**From:** Goodwin, Joanna [<mailto:Joanna.Goodwin@pbworld.com>]  
**Sent:** 28 January 2015 14:02  
**To:** Thomas, Edward  
**Cc:** Fahey, David  
**Subject:** P132338/CE - Land north west of Hereford (Three Elms, Between Roman Road and Kings Acre Road, Hereford,

**SITE:** Land north west of Hereford (Three Elms, Between Roman Road and Kings Acre Road, Hereford)  
**TYPE:** Pre-application advice  
**DESCRIPTION:** Urban extension comprising 1090 dwellings, 10ha employment, primary school, community hub, transport interchange and open space  
**APPLICATION NO:** P132338/CE  
**GRID** OS 348422, 241717  
**REFERENCE:**  
**APPLICANT:** The Church Commissioners for England  
**DATE OF THIS RESPONSE:** 28 January 2015

**DESCRIPTION:** Pre-application advice for an urban extension comprising 1090 dwellings, 10ha employment, primary school, community hub, transport interchange and open space.

*Figure 1: Environment Agency Flood Map for Planning (Rivers and Sea), January 2015*

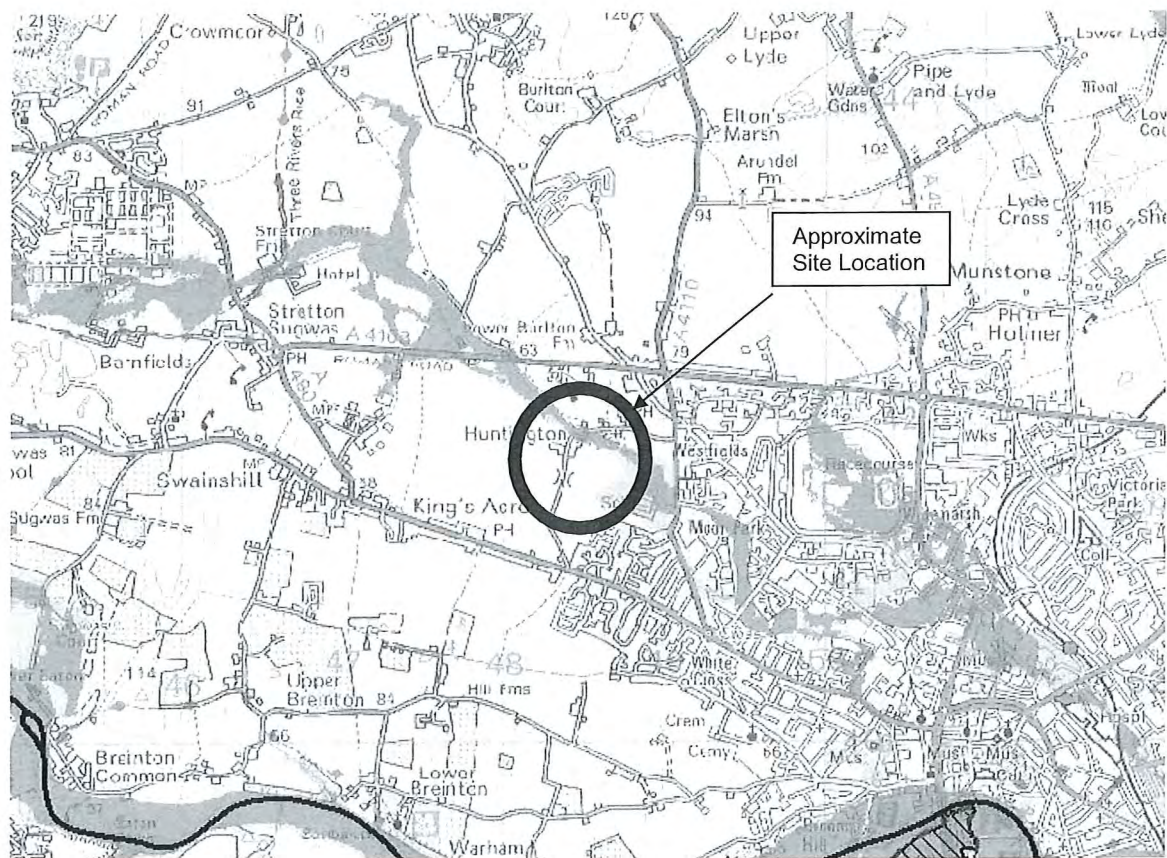
Review of the Environment Agency's Flood Map for Planning (Figure 1) indicates that the majority of the site is located within the low risk Flood Zone 1. However, the centre of the site is indicated to be located within the medium risk and high risk Flood Zones 2 and 3 associated with the Yazor Brook ordinary watercourse.

Given the sensitivity of the development and the extent of the site within Flood Zone 2 and 3, the Applicant should consider the potential effects of climate change when assessing the Flood Zones. The SFRA advises that the extent of the modelled flood extents could be increased by 10m to take into account climate change effects, although modelled flood data is always preferred and we recommend that the Applicant consults with the Environment Agency regarding the availability of modelled data. Alternatively Environment Agency Standing Advice suggests that 300mm can be added to the modelled or predicted flood level for the present day events.

considers fluvial flood risks at the location of the proposed school as this is indicated to be in close proximity to the Yazor Brook and could be at risk when the potential effects of climate change are considered.

In accordance with Environment Agency standing advice, the planning application should be supported by a Flood Risk Assessment (FRA) undertaken in accordance with National Planning Policy Framework (NPPF) and its supporting Technical Guidance. This is summarised in Table 1.

The FRA should clarify the extent and depth of fluvial flood risk within the site boundary and consider the potential effects of climate change. The FRA should also identify how flood risk to the proposed development has been minimised, how the development has been made safe, how the impacts of the development on people and property elsewhere have been avoided, and the management of the additional surface water runoff generated by the proposed development. The Applicant should also give consideration to any other minor watercourses that could pose flood risk to the development as well as anecdotal evidence.
